A7. POST-APPLICATION DISCUSSION

COMMENTS BY THE PRIMROSE HILL CONSERVATION AREA ADVISORY COMMITTEE

Primrose Hill Primary School Princess Road NW1 8JL Listed Building PRE-APP

A7.2.1 10.05.16. Robert Loader and David Walter met Tanya Skelli-Yaoz and Sarah Freeman at LB Camden to present the proposals. The points arising from the meeting are set out below.

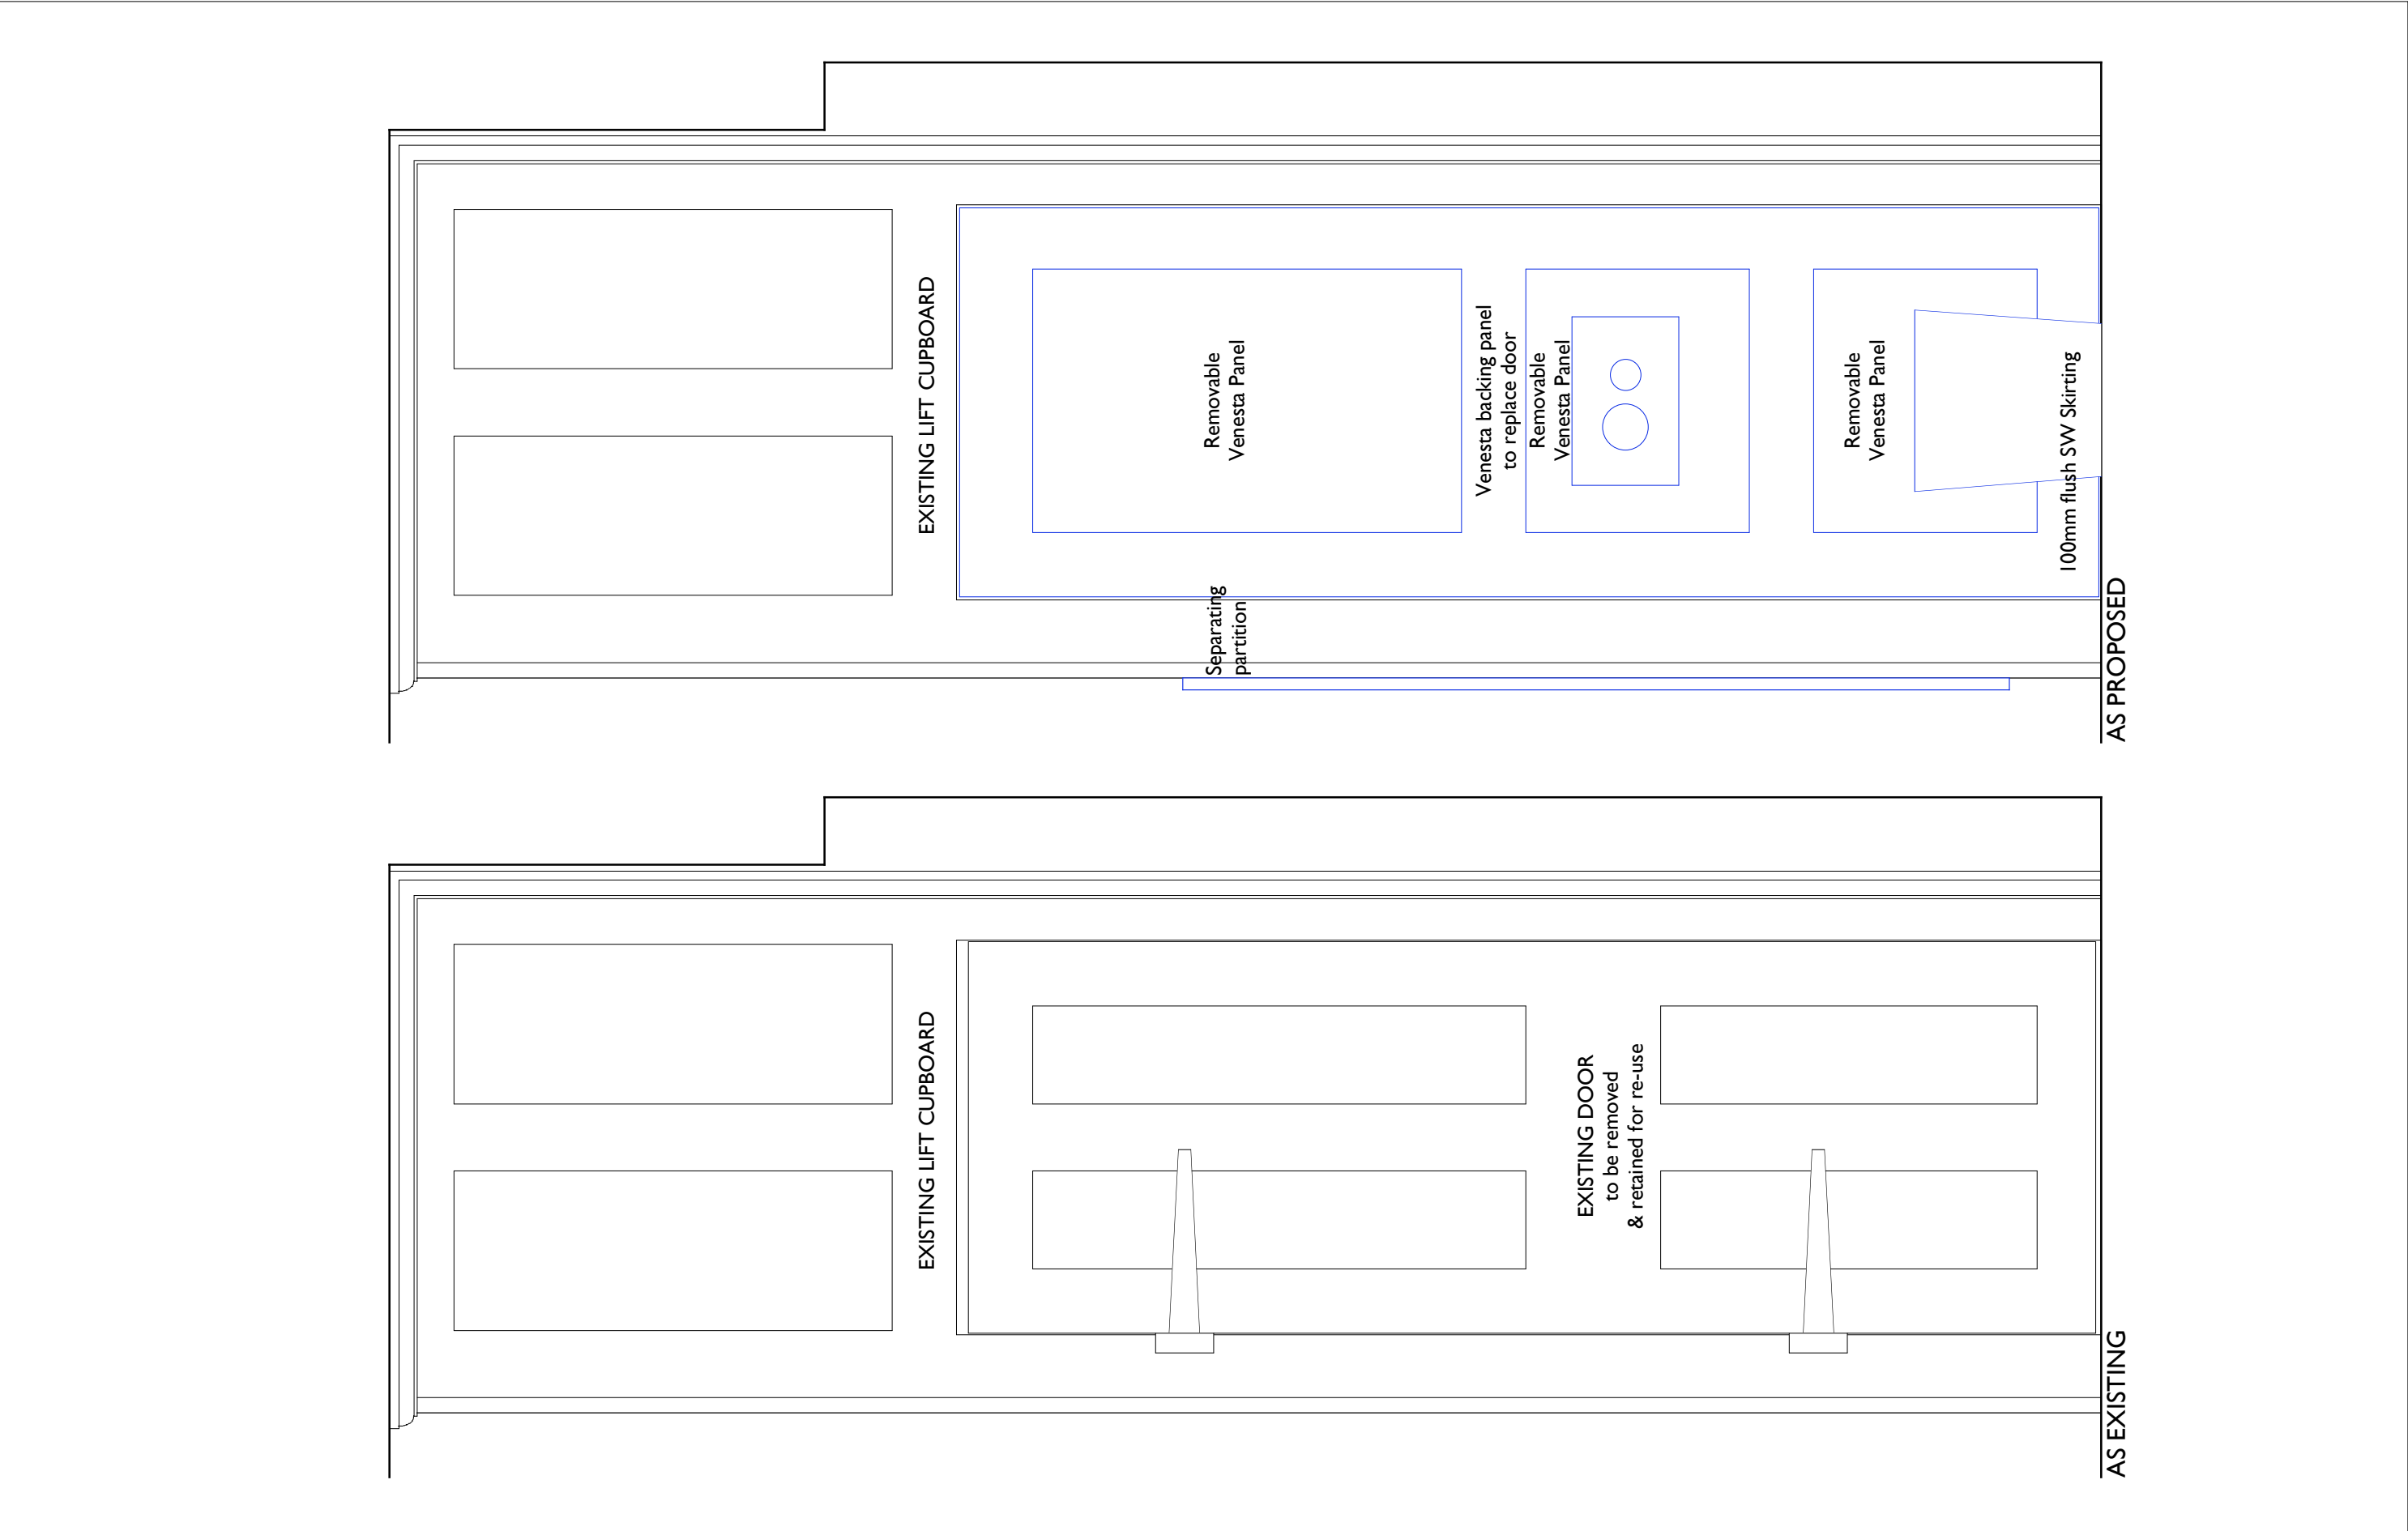
5. LBC will resist removal of the original lift housing/ current cupboard in Reception WCs. RL to assess effect of floor area loss if WCs are moved to side.

Response: Revised proposals are attached below showing the original lift cupboard to be retained with the non-original door replaced by access panels and a new WC to be located in front. The adjacent door and frame to the cupboard under the stairs is reversed. Drawings attached below: PRPS PR 332_G and PRPS PR 512_G.

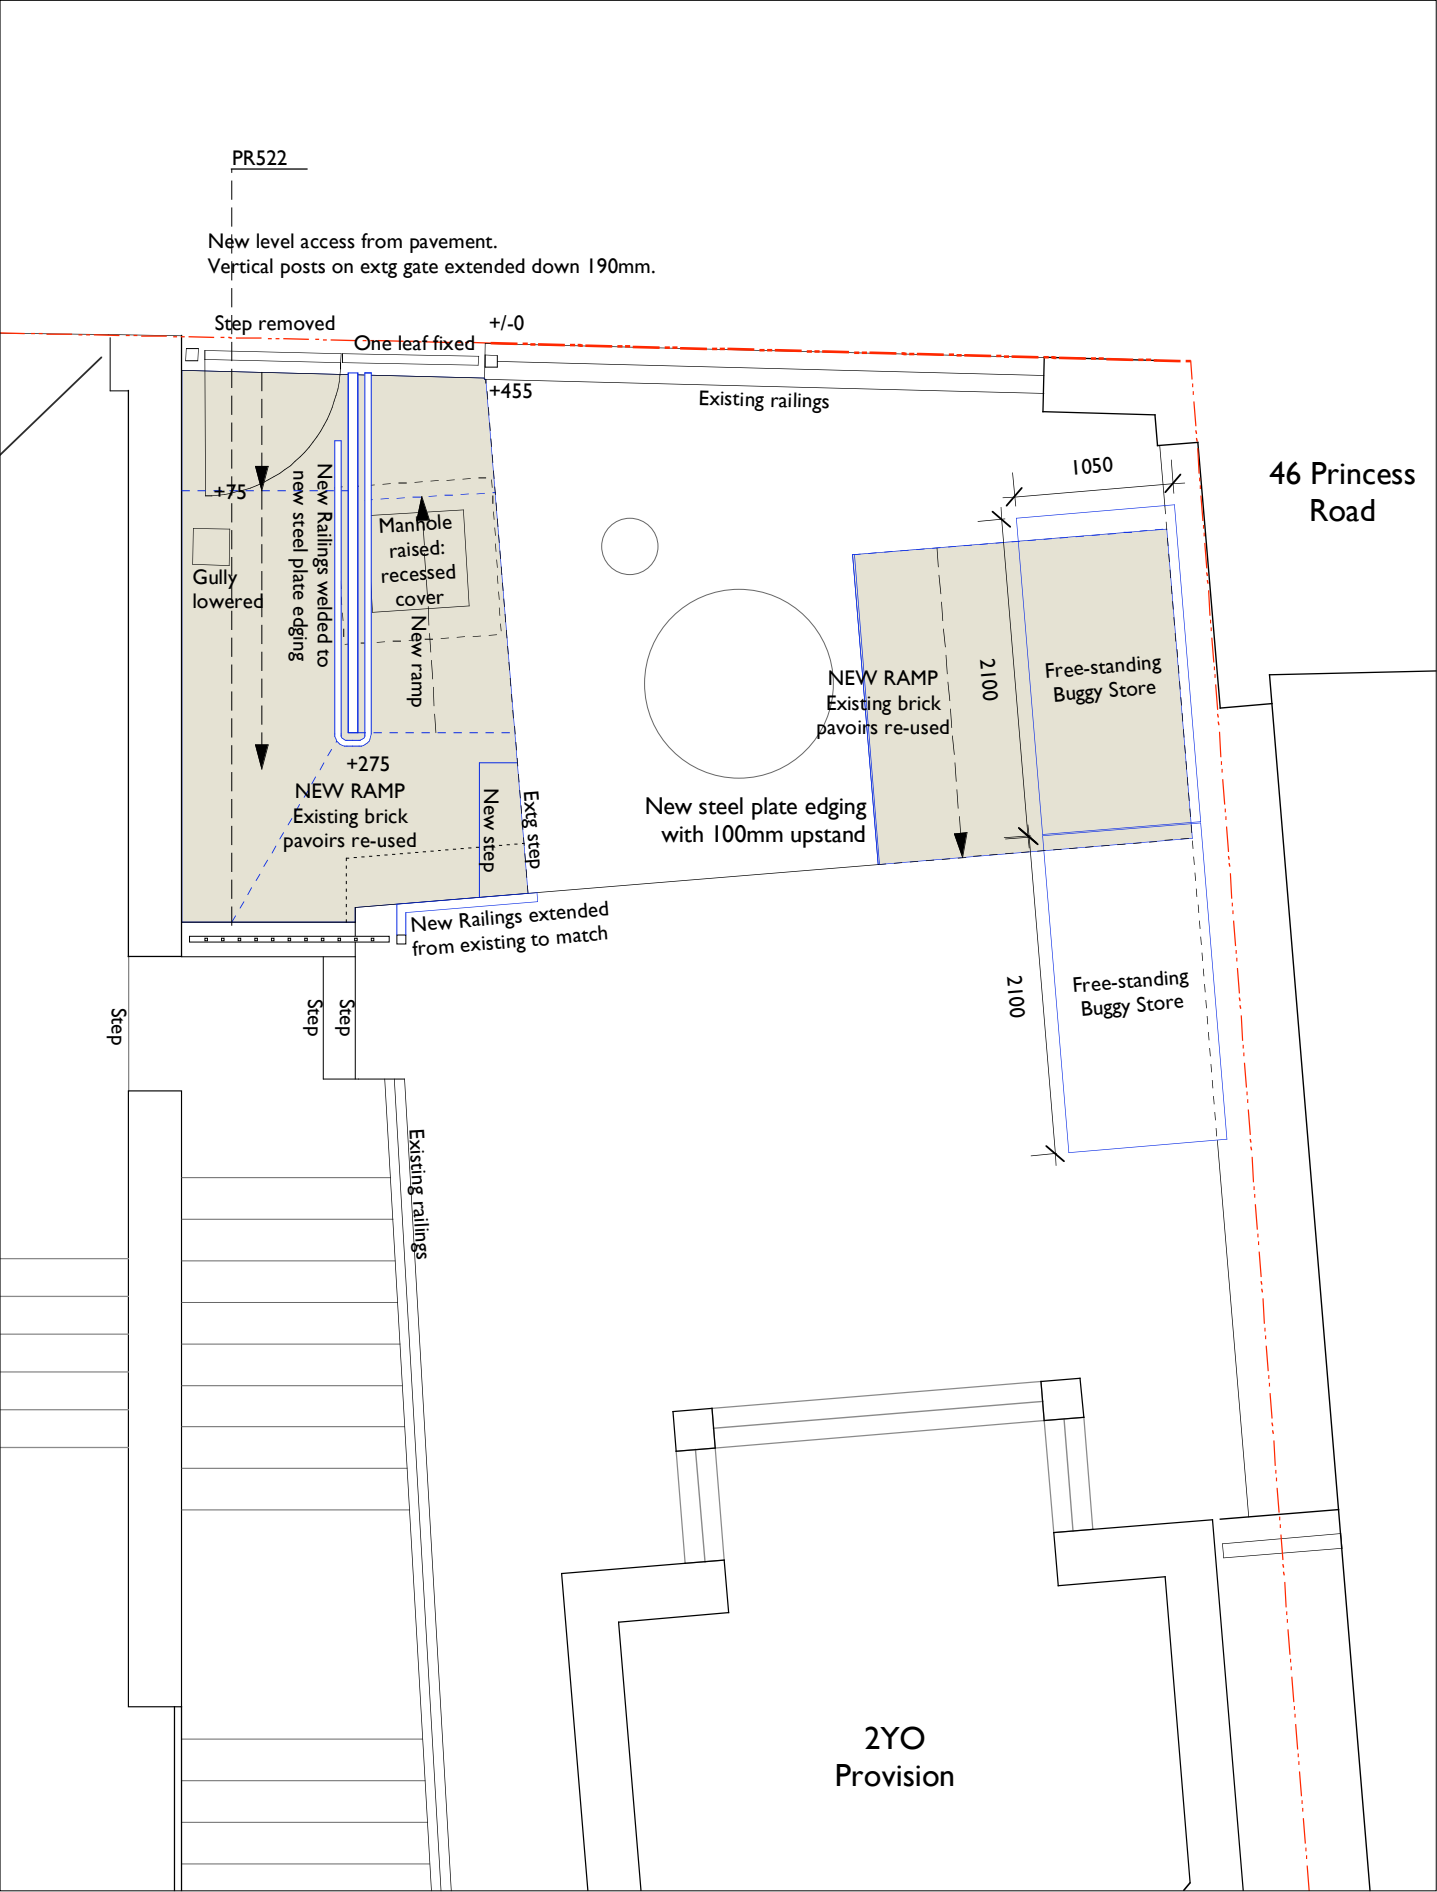
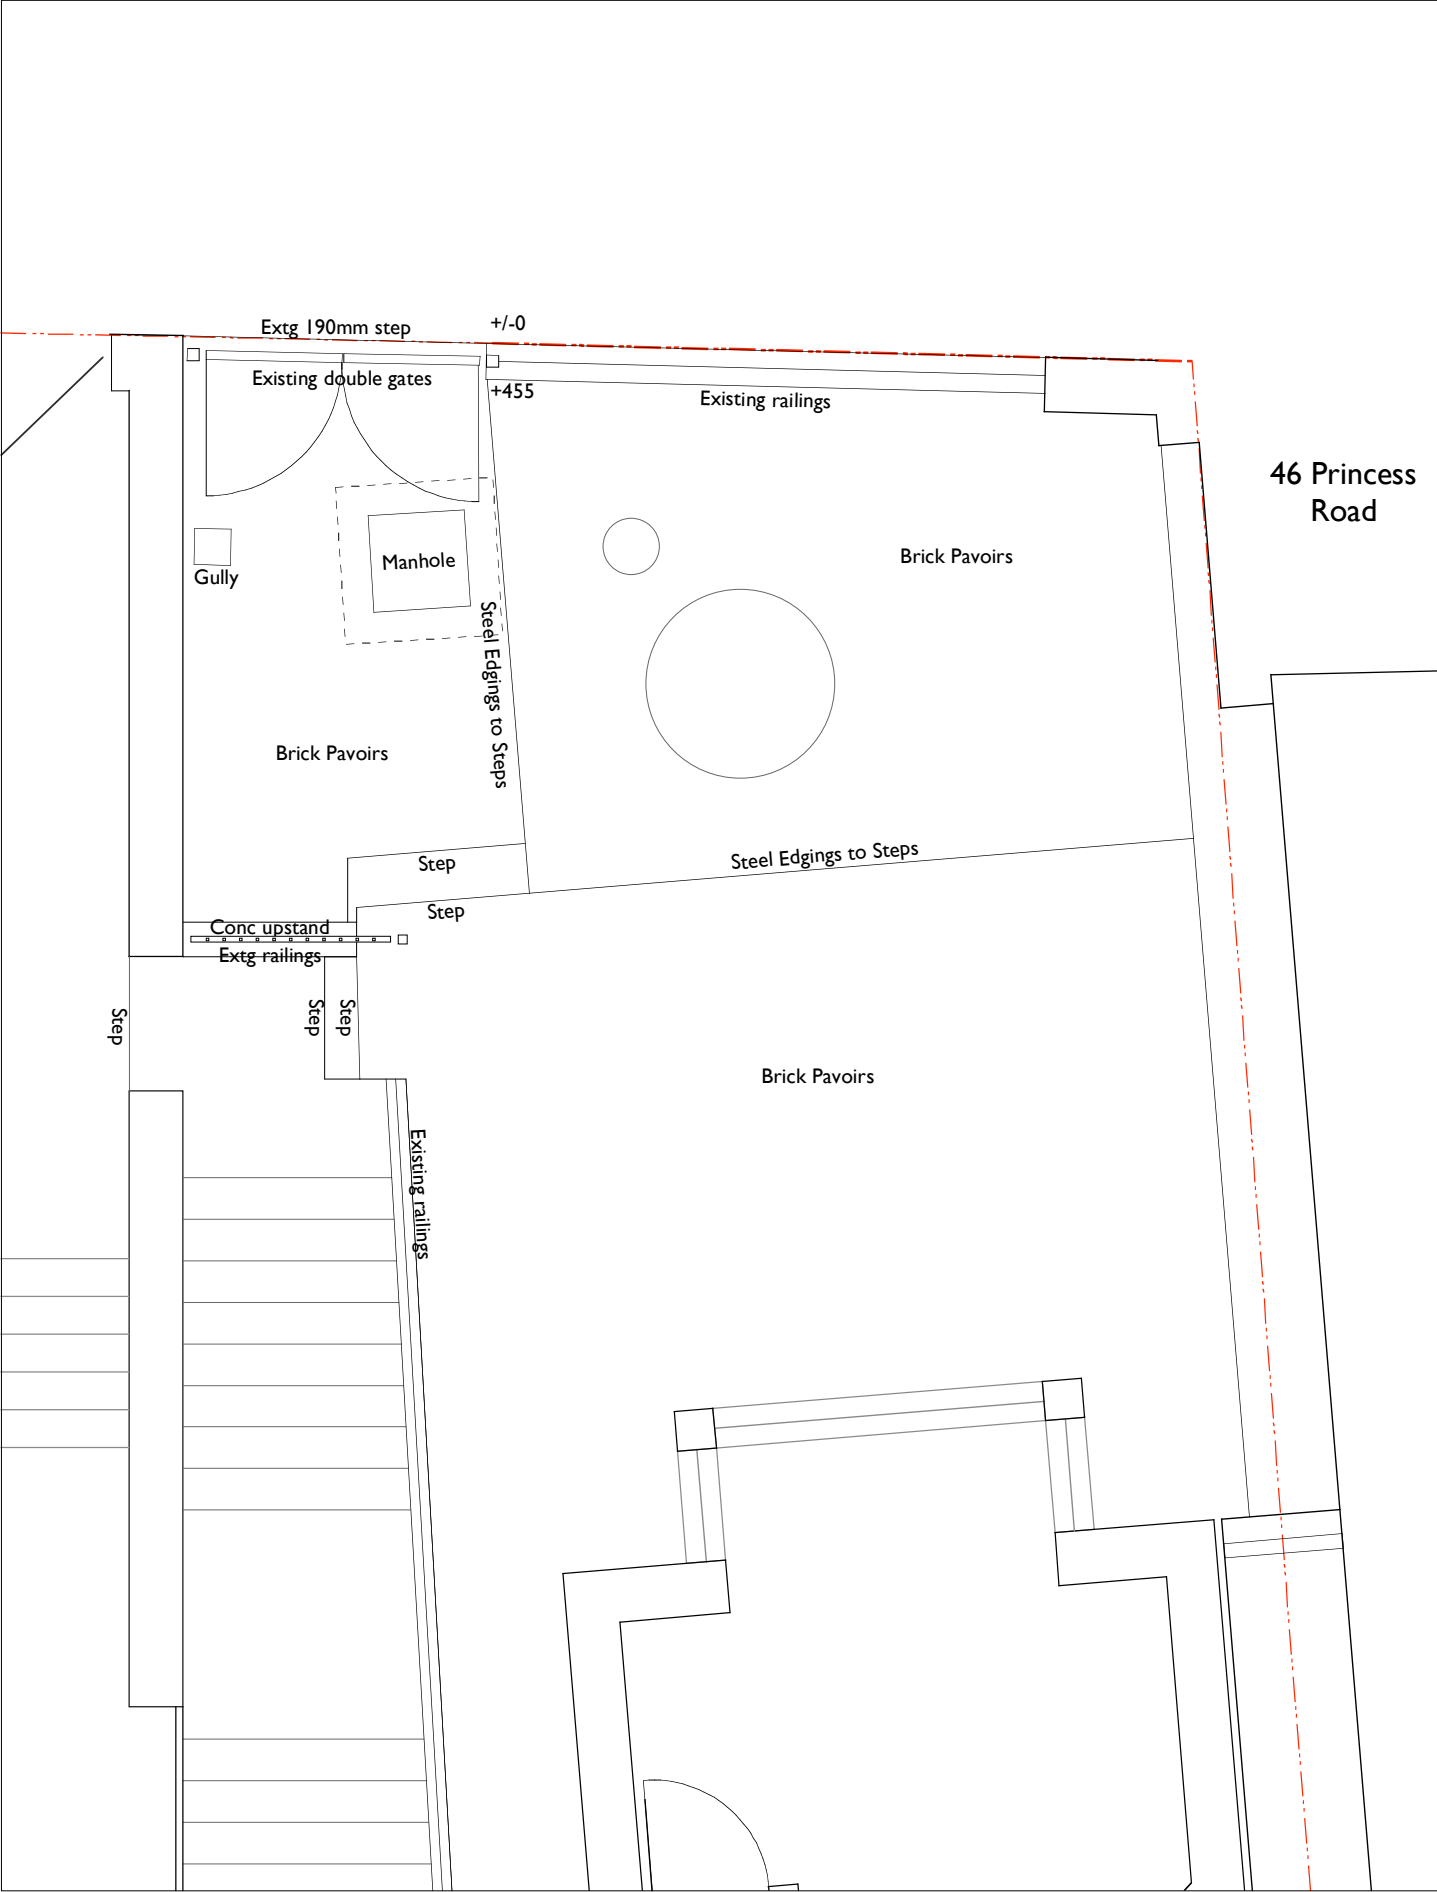
At the front of the School House, we would need to see details of the treatment of the foot of the gate to lower the gate to the reduced level of the access ramp. We accepted that the access ramp was a good solution to the need to provide wheeled access. We would object to the location of a buggy store as shown. The front area of the house is a key element in the Listed Building and its setting, as well as contributing to the character and appearance of the conservation area.

15. Details of gate alterations, ramp and railing at the front of Caretaker's House to be provided.

Response: A 1:10 detail on entrance gate alterations at the front of the Caretaker's House is attached below: PRPS 350_G, PRPS PR 520_G and PRPS PR 521_G. A section through the ramp with elevation of the new internal guarding is shown in PRPS PR 522_G.
